City of Tualatin

SUBDIVISION REVIEW FINDINGS AND DECISION FOR SB 14-02, HEATHER RIDGE

This staff report recommends approval of a 16-lot and 2-tract plan for the Heather Ridge Subdivision, as shown on plans submitted September 17, 2014 attached as Exhibit A, with conditions of approval as outlined in the staff report.

JOB NUMBER: 3895
 SHEET: 03

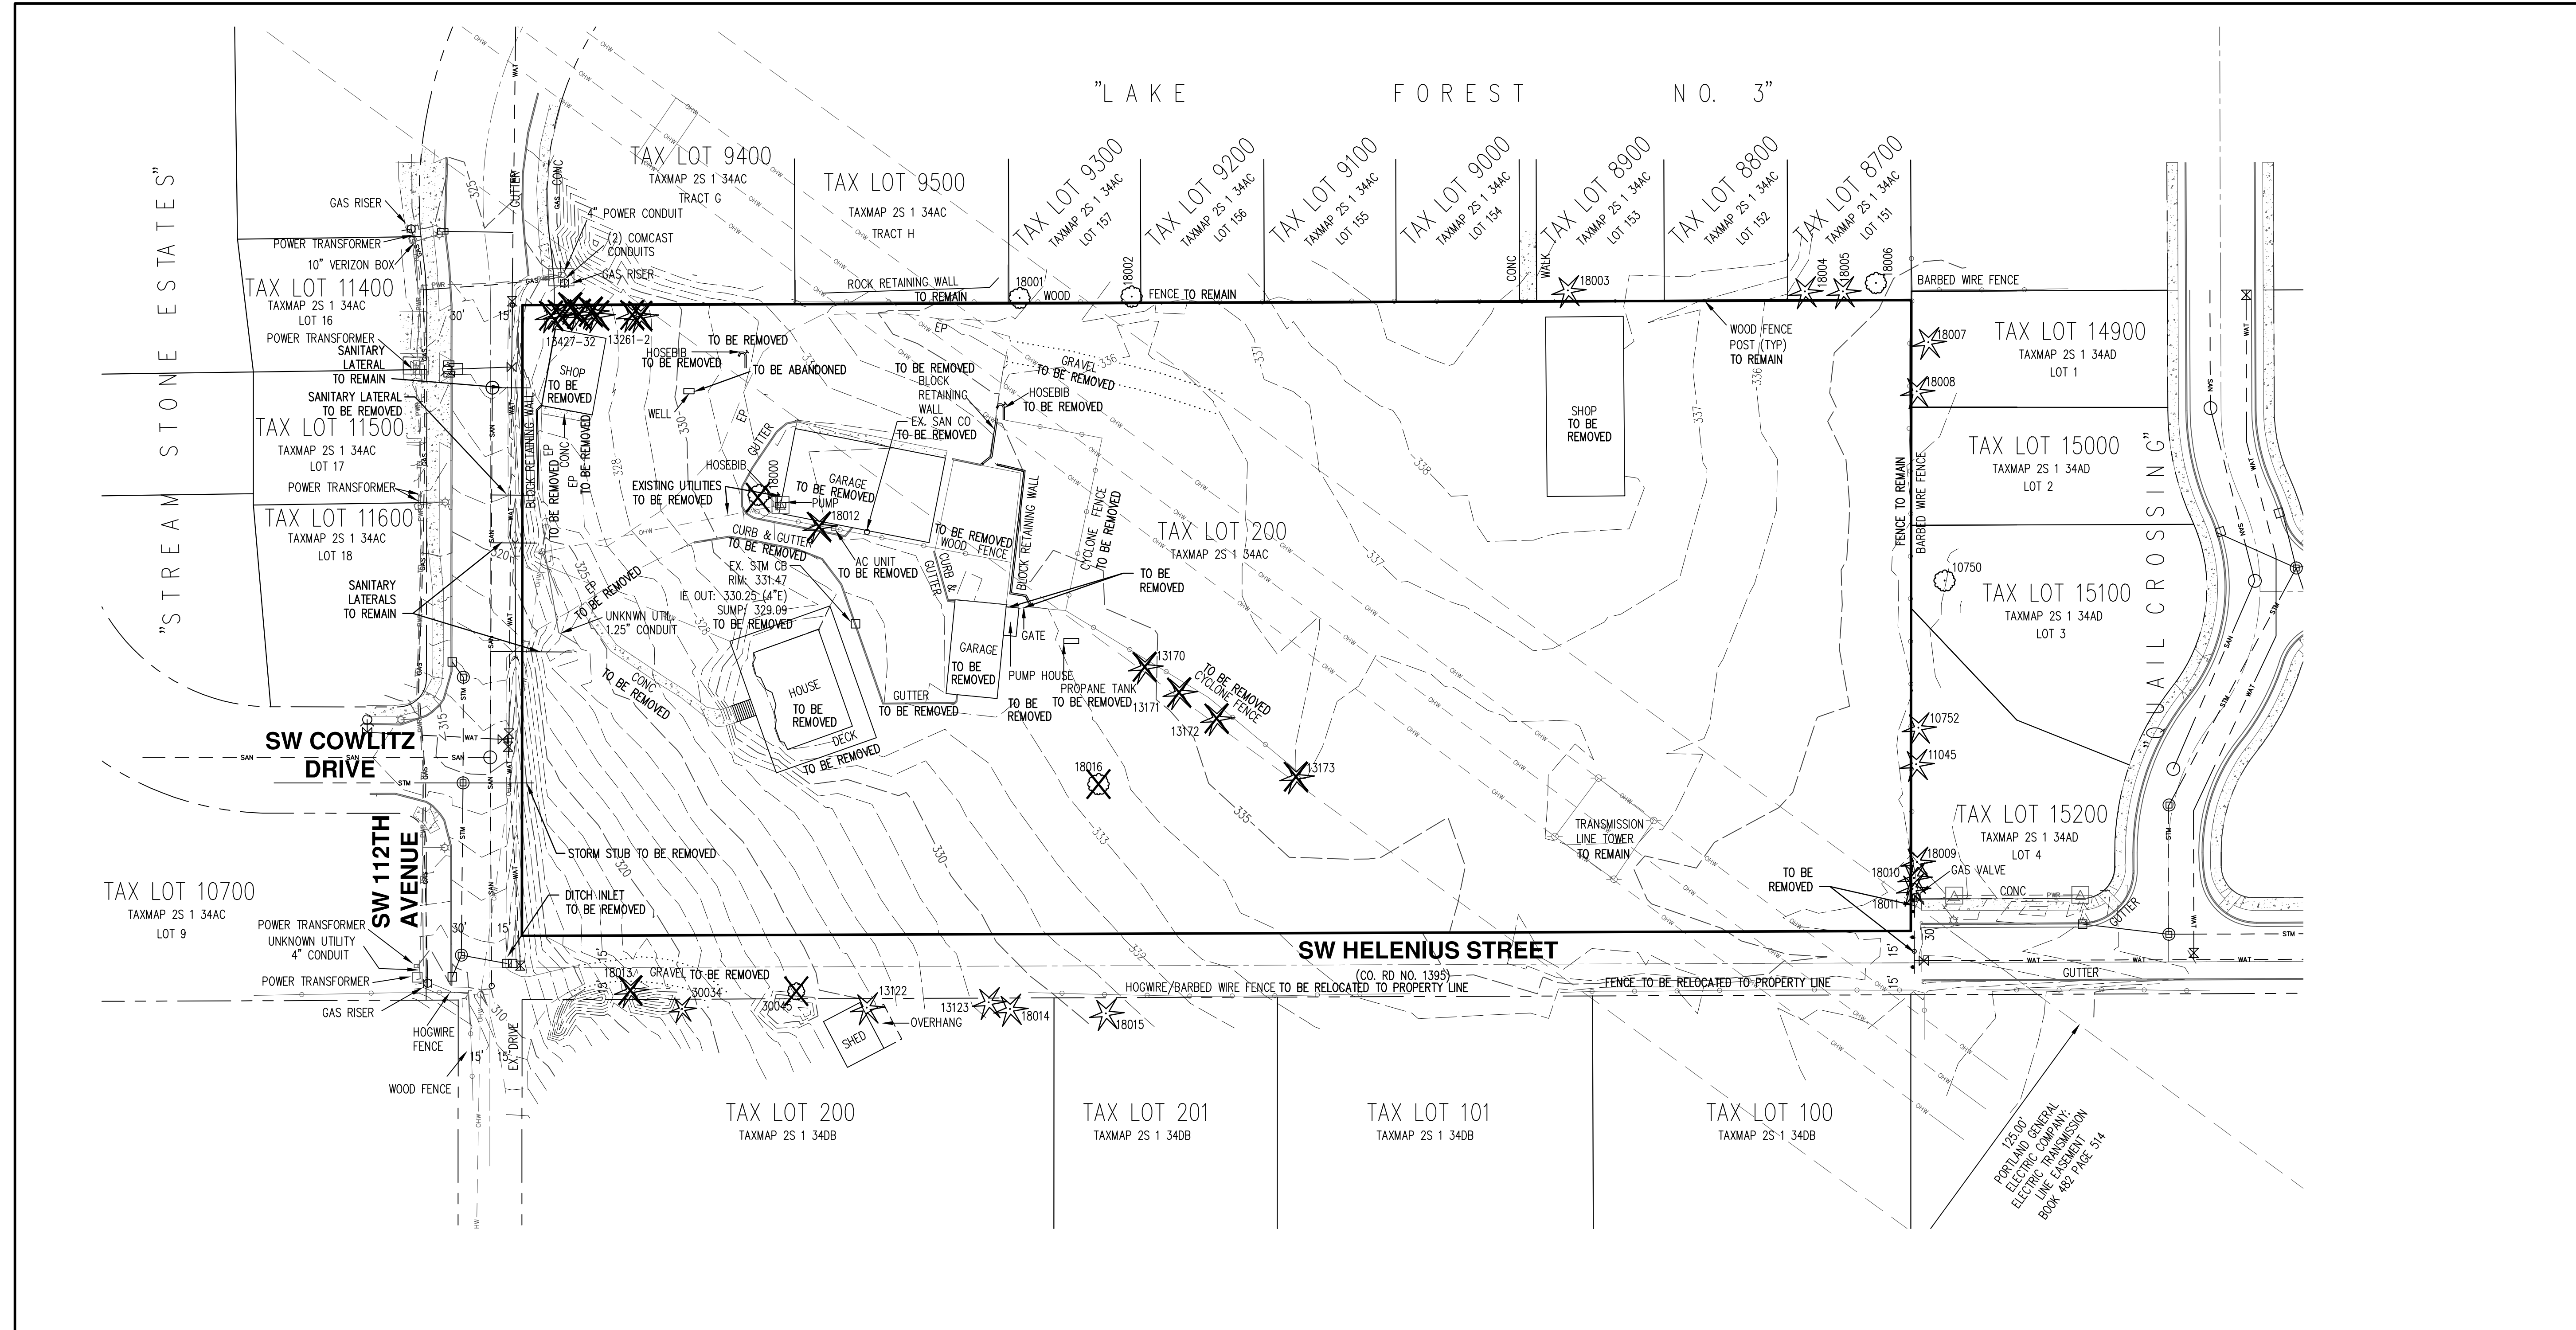
A revised Preliminary Plat dated October 22, 2014 shows that the applicant is proposing 16-lots and 2-tracts. All existing structures are proposed to be demolished. Lot sizes range from 6,186 to 19,330 square feet. The average lot size is 9,867 square feet which is greater than the minimum 6,500 square feet. The proposed average lot widths are not less than 62.5 feet along the streets. The proposed average lot widths for lots adjacent to the SW 110th Place cul-de-sac are greater than the minimum 30 feet on a cul-de-sac. This requirement is met.

Tract A is proposed to be a public water quality facility and Tract B is proposed to be a pedestrian accessway. Both are to be dedicated to the City of Tualatin. This is acceptable. The applicant will submit final plans that show Tract A as a public water quality facility and Tract B as a pedestrian accessway, both to be dedicated to the City of Tualatin, for review and approval.

- *The applicant shall submit final plans that show Tract A as a public water quality facility and Tract B as a pedestrian accessway, both to be dedicated to the City of Tualatin, for review and approval.*

**PRELIMINARY
 CIRCULATION PLAN**

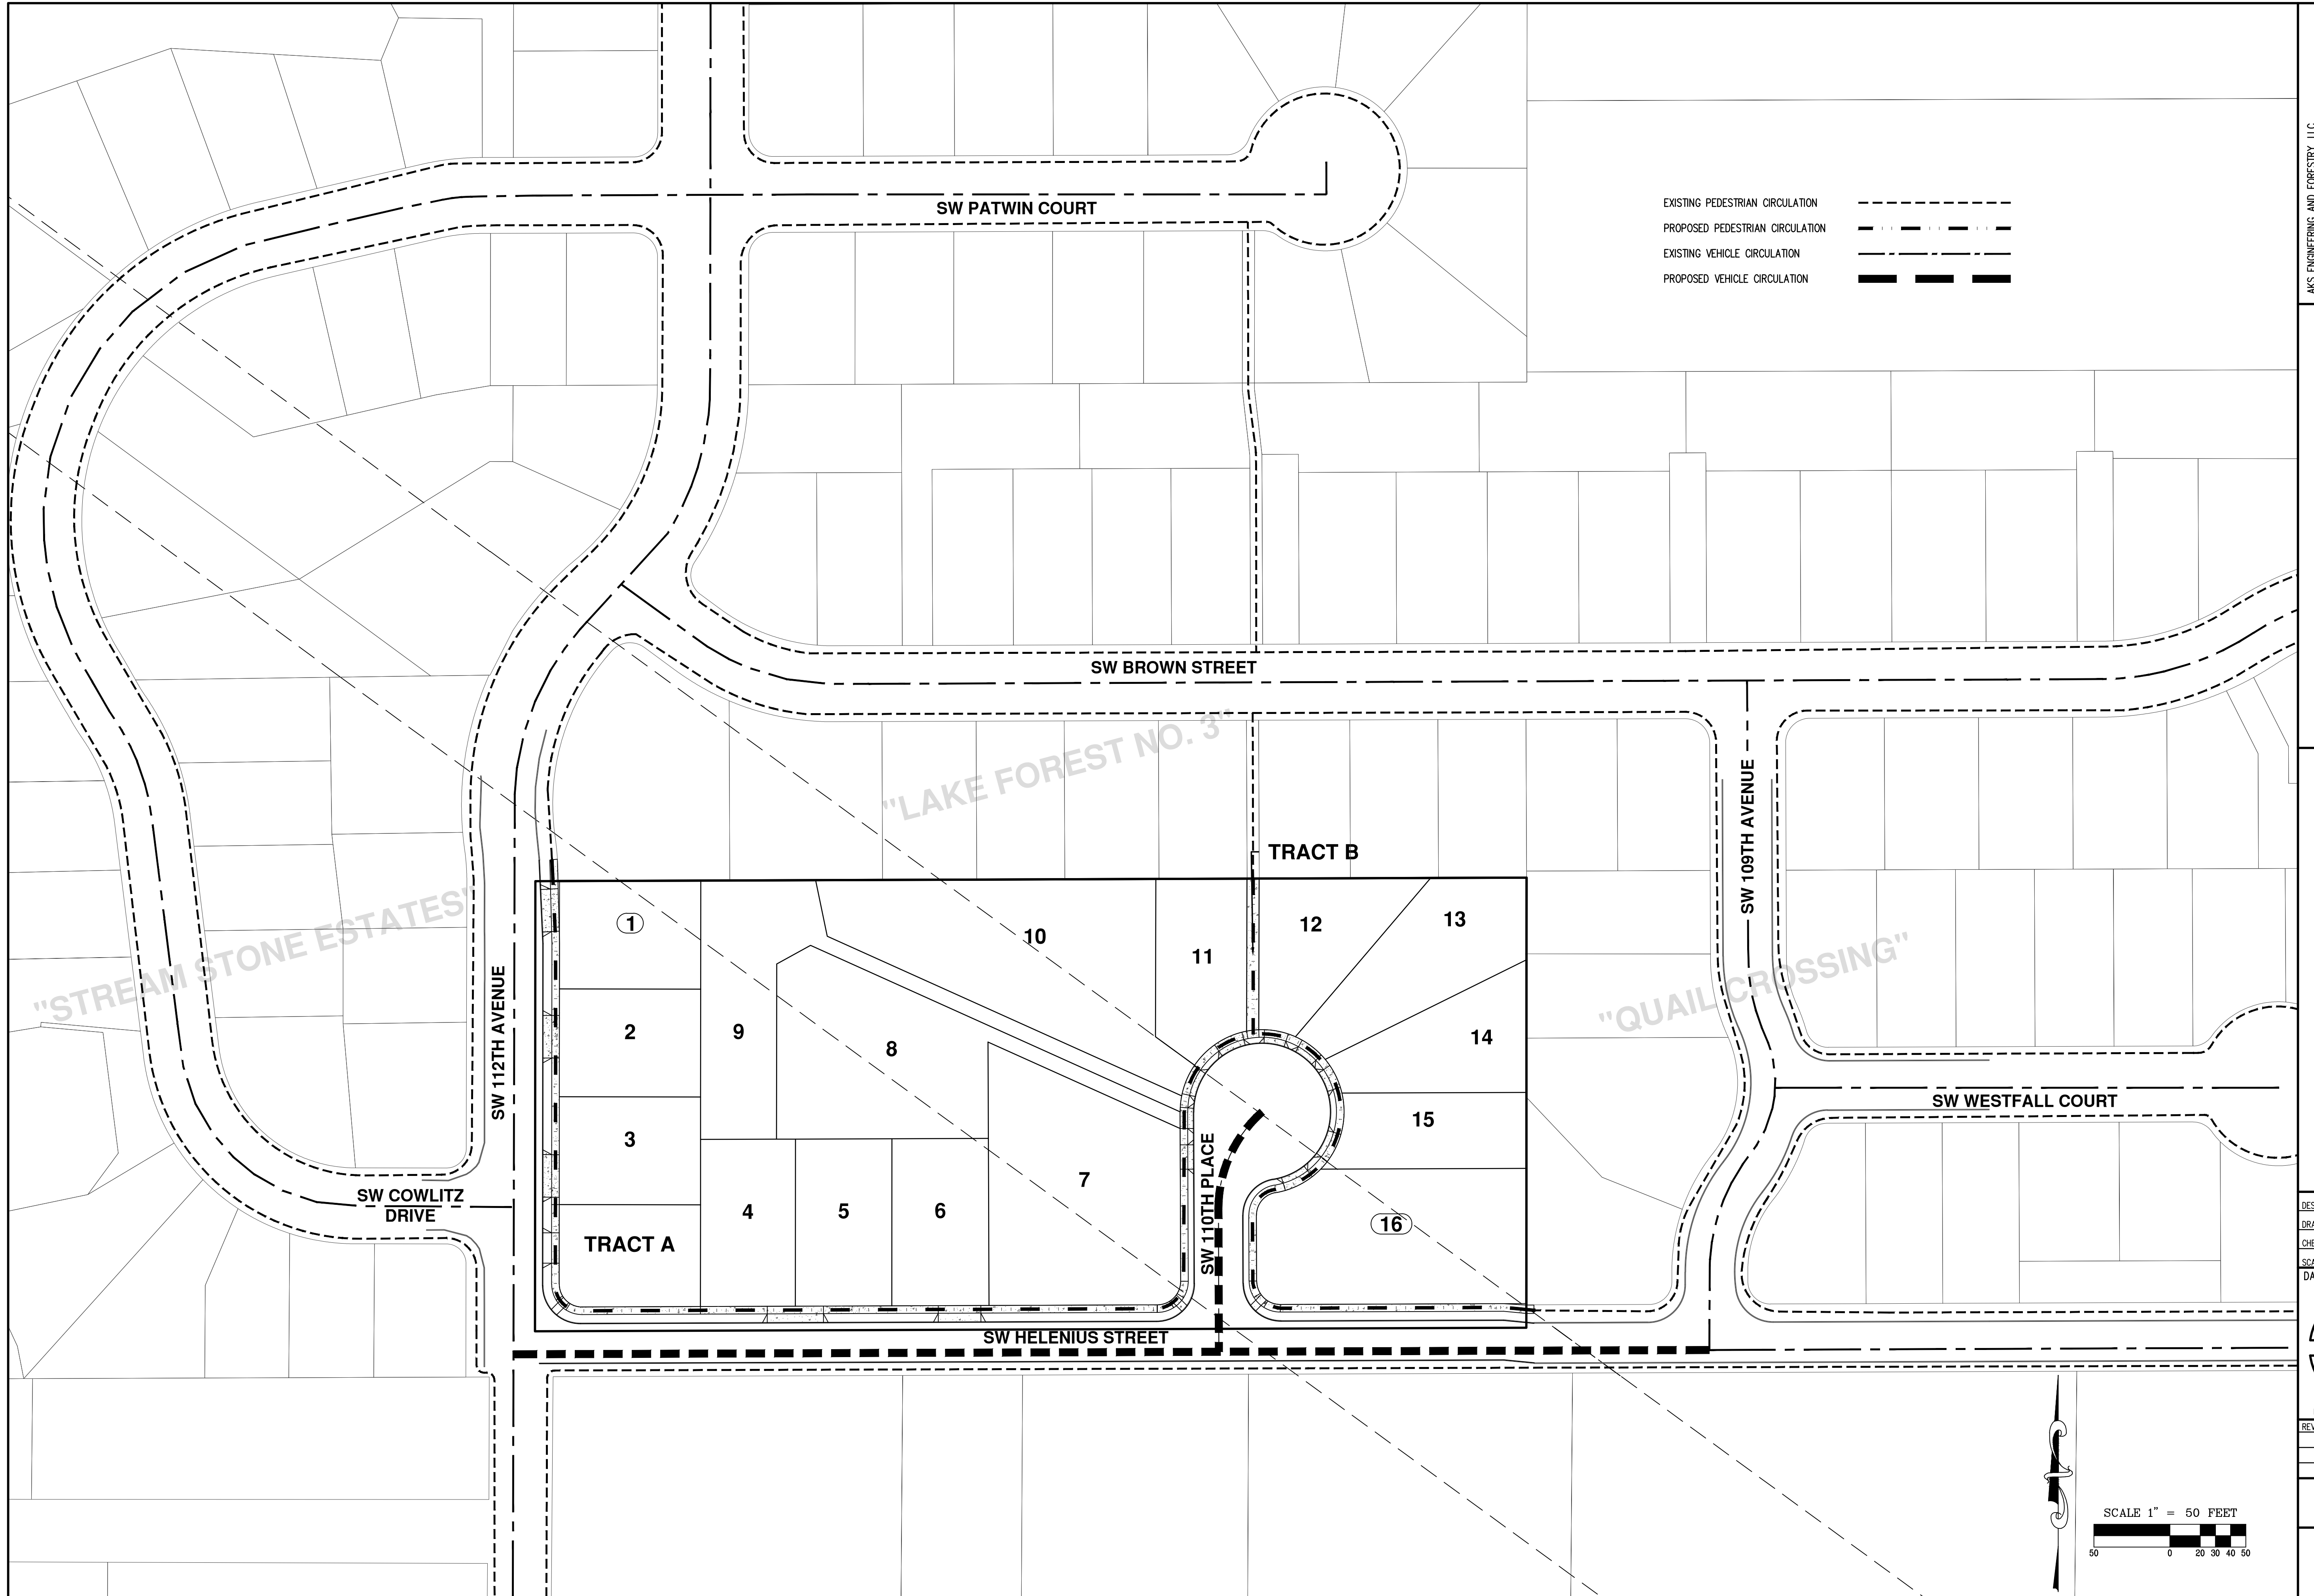
The plans show accesses from lots 1-3 to SW 112th Avenue, a shared access for lots 4&5 and a single access for lot 6 to SW Helenius Street, and single accesses for lots 7 & 10-16 to plus a shared access for lots 8 & 9 to SW 110th Place. Both SW 112th Avenue and SW Helenius Street are classified as Minor Collectors with access spacing restrictions. The spacing of accesses on SW 112th Avenue are approximately 55 and 63 feet apart. The spacing of accesses on SW Helenius Street is approximately 75 feet apart. The City Engineer has interpreted this access spacing to be acceptable in this circumstance.

The plans show access widths for single home lots to be between approximately 15 and 28 feet wide and the shared accesses to be between approximately 13 and 37 feet wide. The minimum access width is 10 feet and the maximum widths are 26 feet for a one or two car garage and 37 for a 3 or more car garage. The applicant will need to submit final plans that show accesses for all lots to a public street a minimum of 10-feet wide and a maximum of 26 feet wide for one or two car garages and 37-feet wide for three or more car garages, for review and approval.

The plans show an extension of an existing 8-foot wide concrete accessway identified as Tract B. This is shown between lots 11 and 12 and connect to SW 110th Place. This is acceptable. The applicant will need to submit final plans that show extension of an existing 8-foot wide concrete accessway identified as Tract B between lots 11 and 12 and connect to SW 110th Place, for review and approval.

- *The applicant shall submit final plans that show accesses for all lots to a public street a minimum of 10-feet wide and a maximum of 26 feet wide for one or two car garages and 37-feet wide for three or more car garages, for review and approval.*
- *The applicant shall submit final plans that show extension of an existing 8-foot wide concrete accessway identified as Tract B between lots 11 and 12 and connect to SW 110th Place, for review and approval.*
